Comment of the Associate Editor

Comments of Referee #1

Reply to comments by referee 1 (Prof. Dr. Birkel) on the manuscript "Incorporating experimentally derived streamflow contributions into model parameterization to improve discharge prediction" by Hartmann et al. The referee's comments are provided in *ITALIC*, our response in regular style.

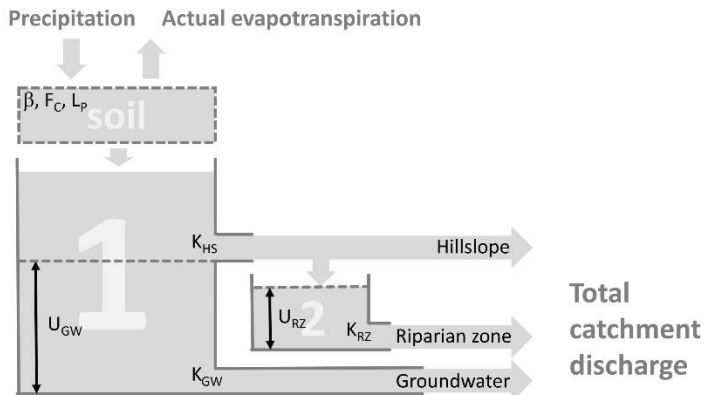
Page 6, line 14: "the first storage" Is this actually correct, i.e. is it really the reservoir marked "1" in Figure 2 and not the soil storage above? The description of the model uses the term "soil storage" quite frequently. It would be helpful to identify this (I assume this is the upper box with dashed lines) in Figure 2. Adding a short explanation in the figure caption of reservoirs 1 & 2 might be helpful.

8.   Thank you for pointing this out. Indeed, soil storage and hillslope storage have been mixed a bit in the original manuscript. This is now corrected in the revised manuscript including an updated sketch of the model structure (Fig. 7 in the revised manuscript) indicating the soil storage explicitly:
